ARKANSAS POWER & LIGHT COMPANY

SUBJECT: Arkansas Nuclear Once - Unit 1
Docket No. 50-313
License No. DPR-51
Facility Operating License Amendment

TECHNICAL JUSTIFICATION
FOR INSTALLATION OF REDUNDANT
INTERNAL HYDROGEN RECOMBINERS

DESCRIPTION OF CHANGES
AND JUSTIFICATION FOR CHANGES TO ANO-1
TECHNICAL SPECIFICATIONS

FIGURE 1

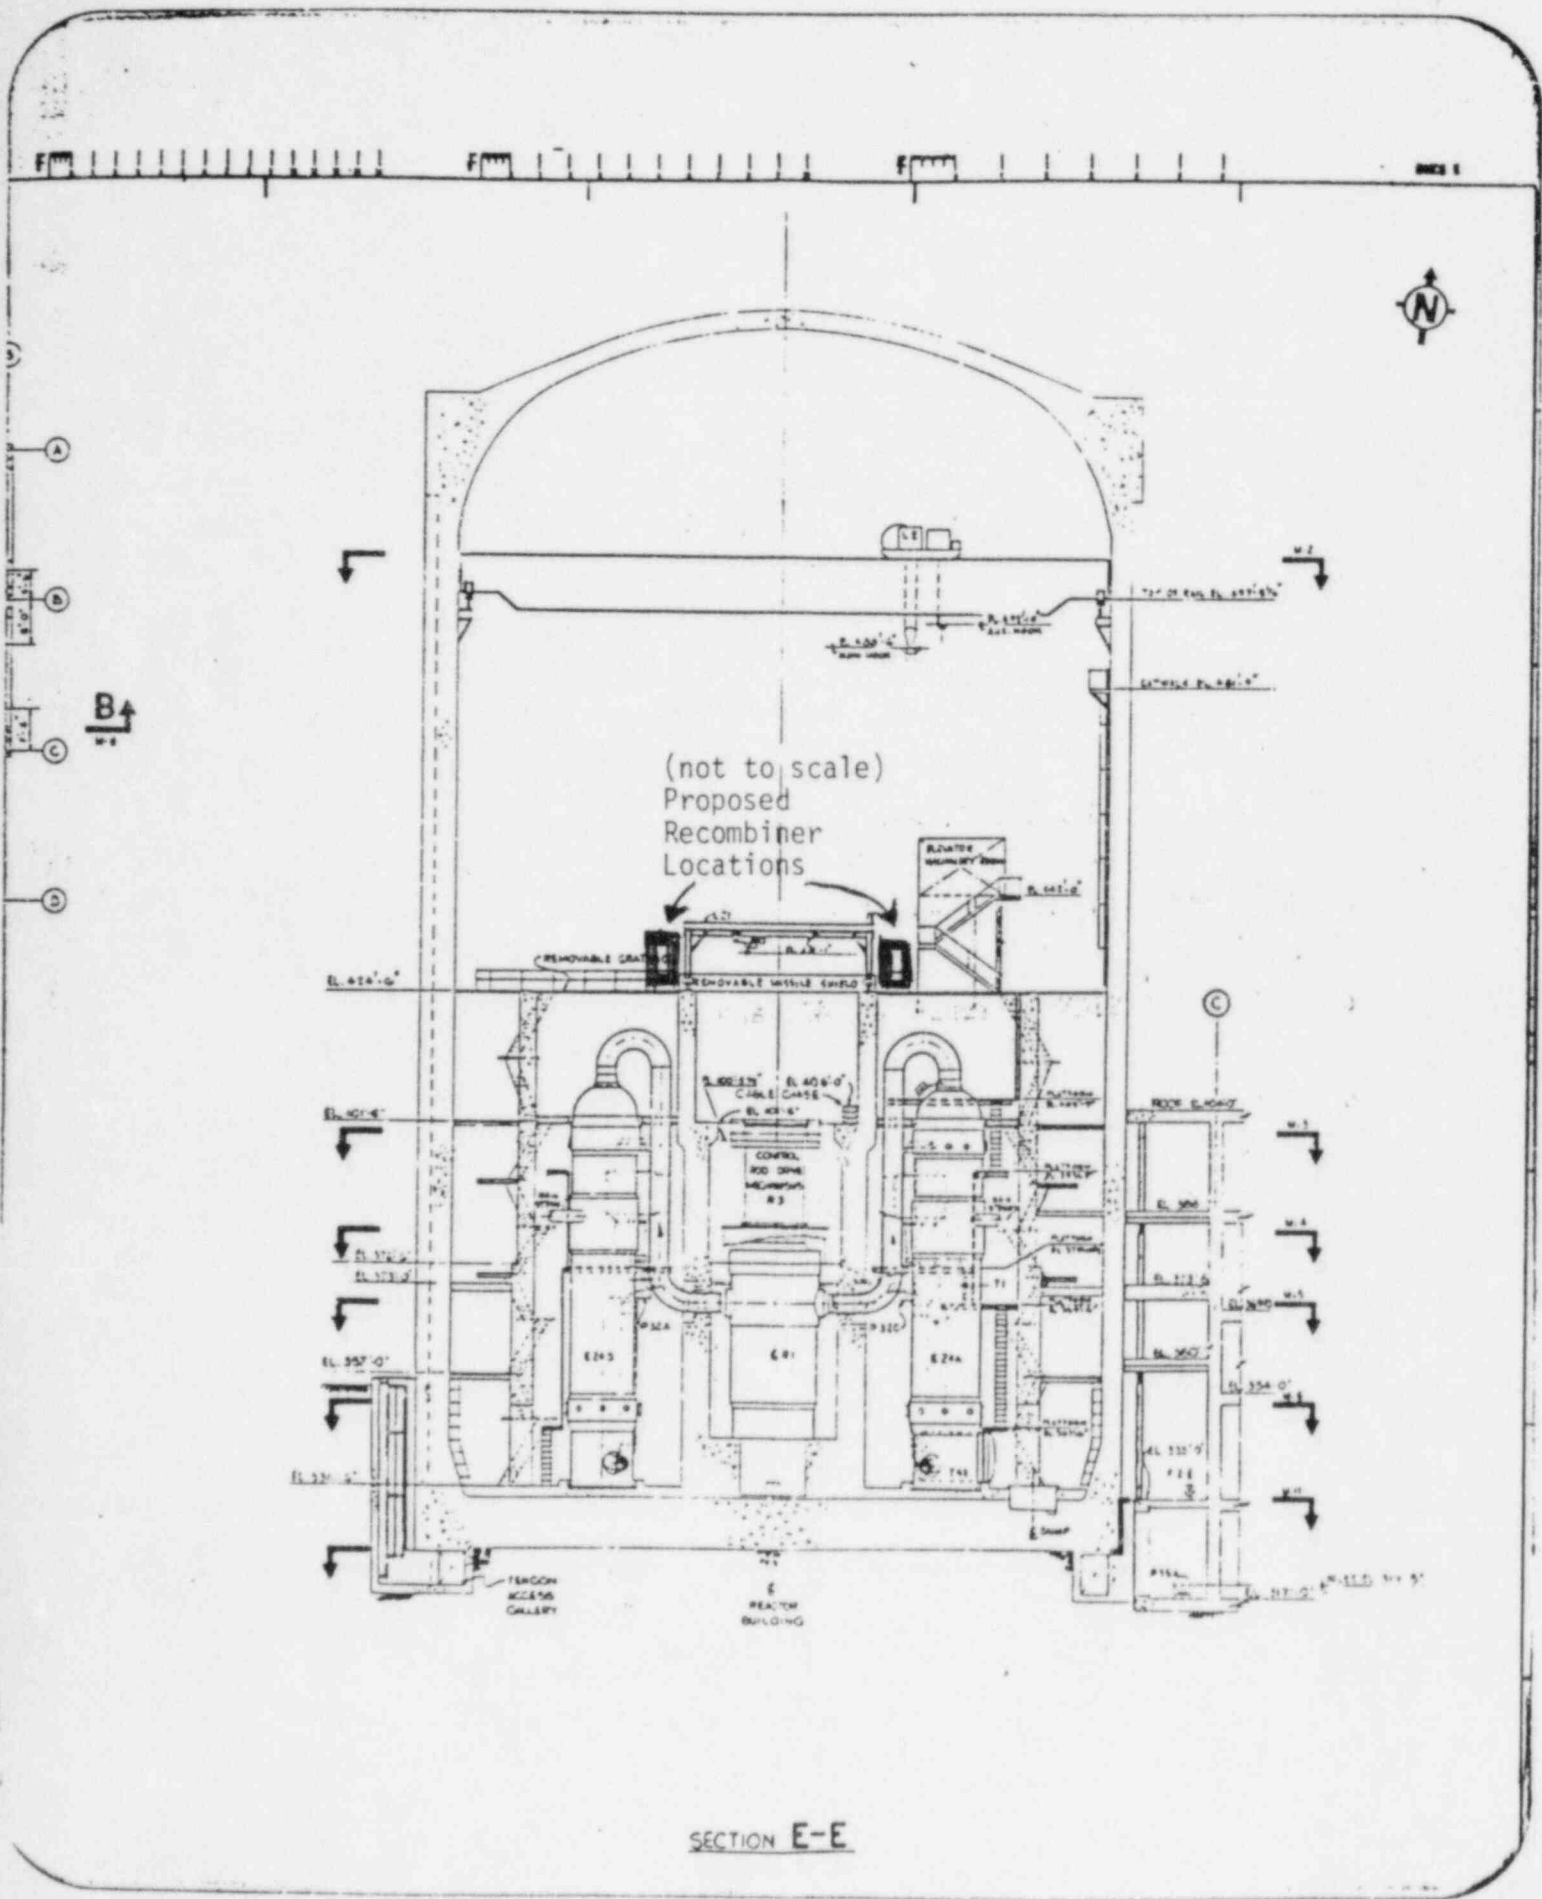
The Westinghouse Model B Electric Hydrogen Recombiner (see Figure 2) consists essentially of a thermally insulated vertical metal duct with metal-sheathed electric resistance heaters provided to heat a continuous flow of containment air (containing a low concentration of hydrogen) up to a temperature which is sufficient to cause a reaction between hydrogen and oxygen. The recombiner operates in the range of 1150 to 1400 °F. Hydrogen and oxygen recombine at approximately 1135 °F.

Figure 1-3. Model B Electric Hydrogen Recombiner - Cutaway

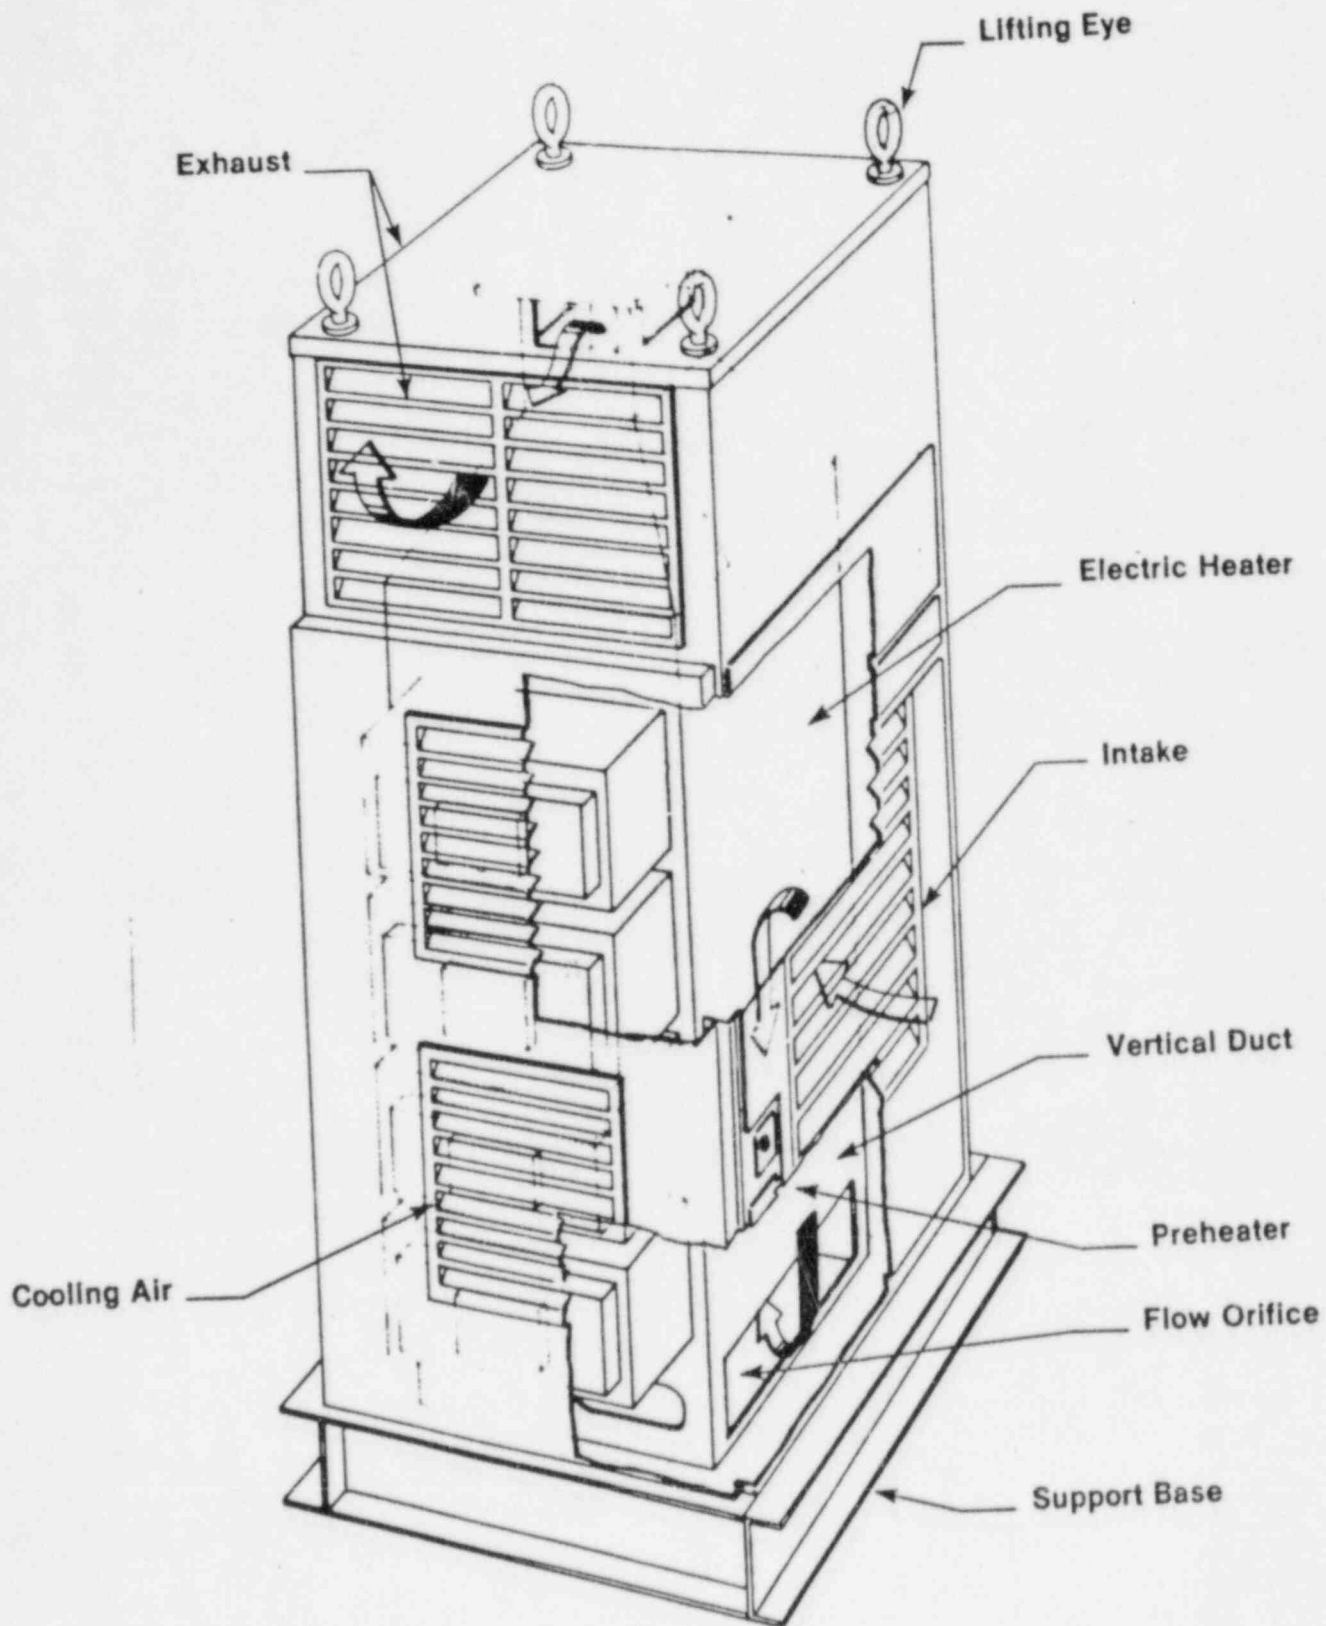
Air and its contained hydrogen enter the recombiner and flow up through the heated section and out the top by natural convection. The intake of the recombiner is located only on one side and the exhaust ports are located above and on the other three sides of the recombiner. The arrangement of intake and exhaust ports serves to ensure that for downflow air currents external to the recombiner, there would be little tendency for recirculation of the recombiner process gases (from the exhaust back into the intake).

No circulation fans are required and the desired flow rate of air is established by providing the proper size inlet flow area through an orifice plate at the bottom of the recombiner. Thus, with the air flow rate regulated by a fixed orifice and with the supply of electric power determined by a control station outside the reactor building, controls are not needed inside the reactor building. Heat added to the reactor building air by the recombiner is removed by reactor building systems already available for other much larger heat loads so that the reactor building air temperature will remain essentially unaffected by the recombiner.
